Redesigned Abutments

PROJECT NAME:	READSBORO	PLOT DATE:	12-APR-2013
PROJECT NUMBER:	BRF 0105 (3)	DRAWN BY:	G. ROKES
FILE NAME:	89J088/STR/s89J088sub.dgn	DESIGNED BY:	W. PELLETIER
PROJECT LEADER:	J. LACROIX	CHECKED BY:	W. PELLETIER
ABUTMENT 1 DETAILS		SHEET	1 OF 5

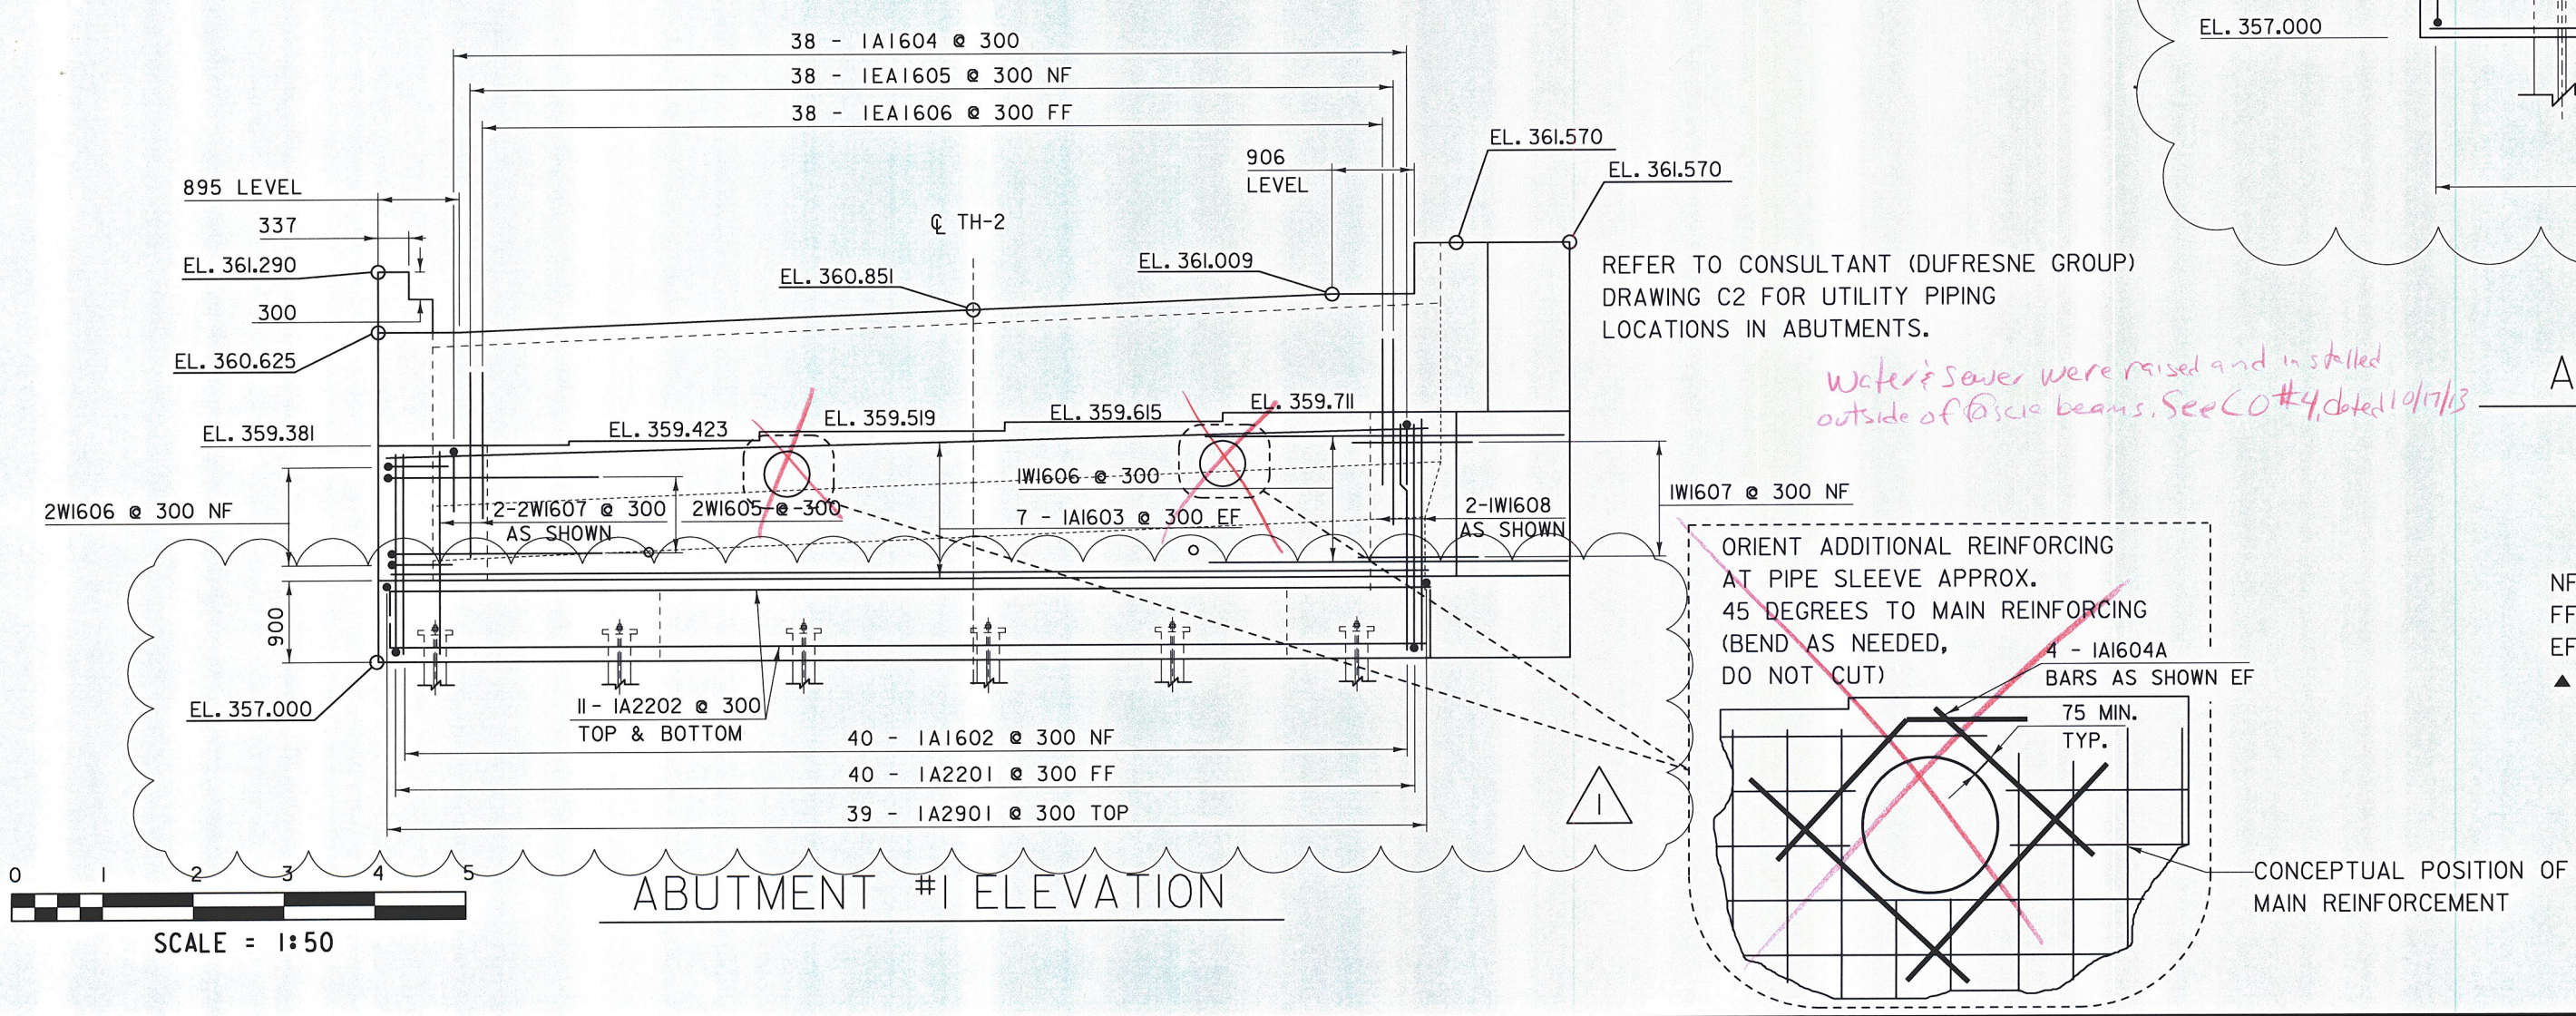
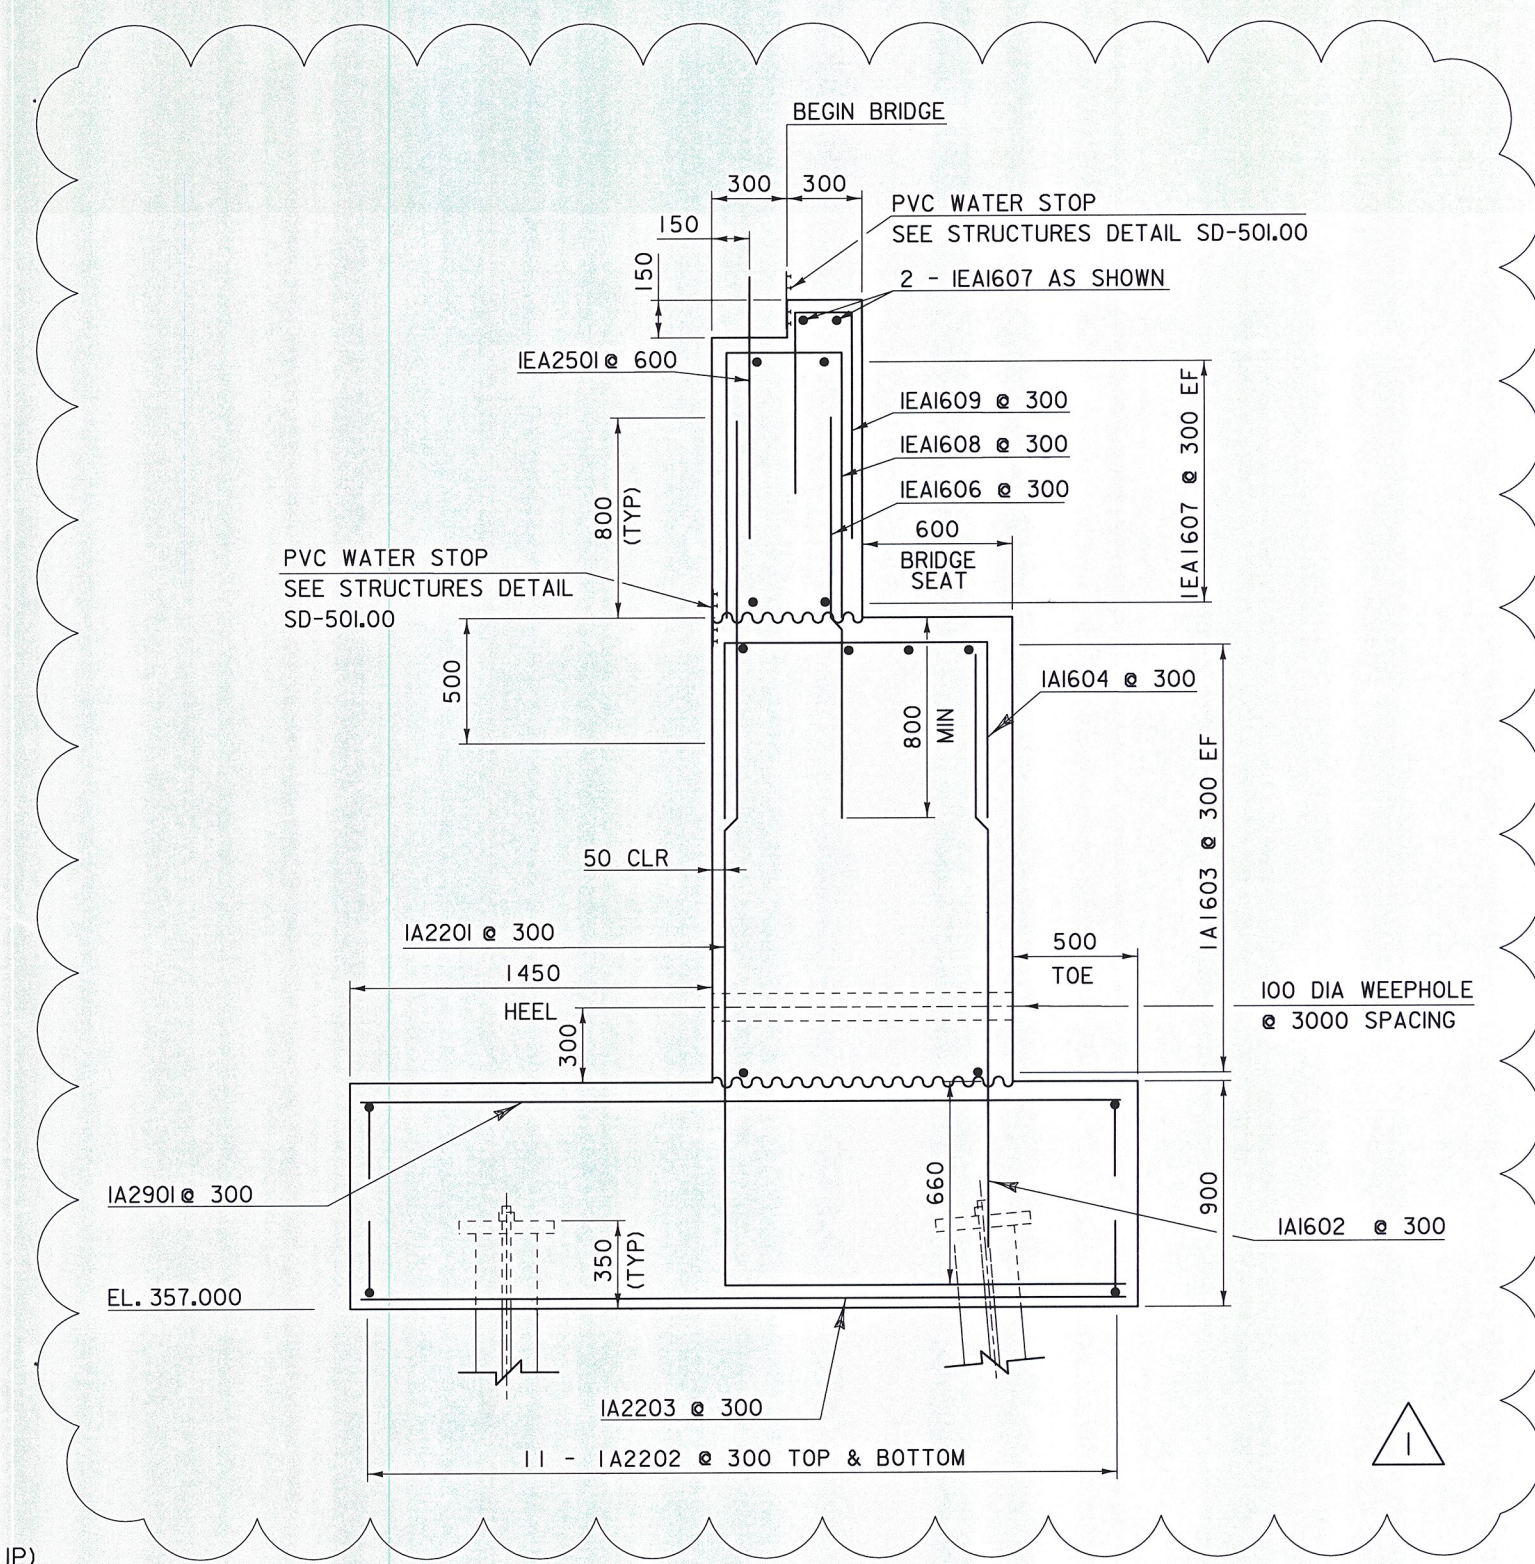
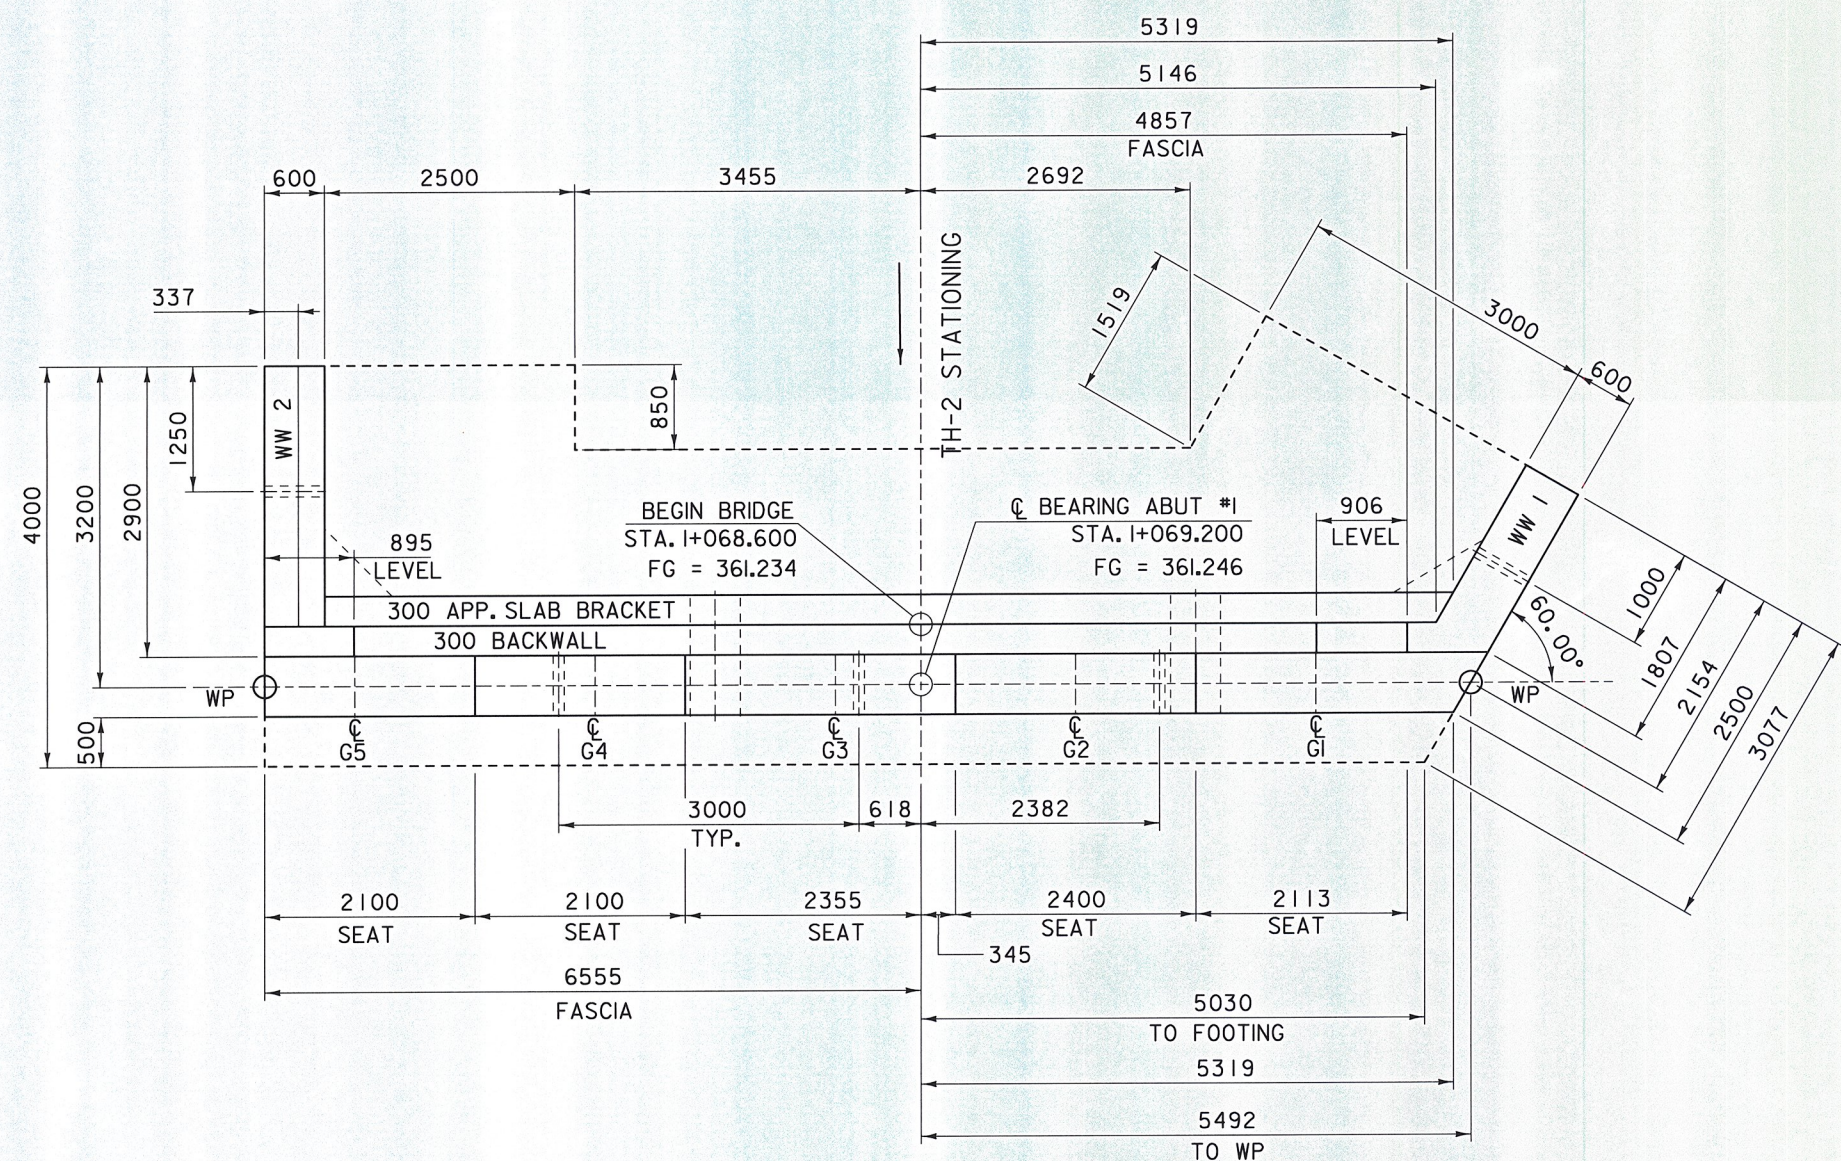
REVISION	DATE	DESCRIPTION	BY
1	04-10-2013	CHANGED STEM WIDTH AND FIXED REBAR AS APPROPRIATE	MRU
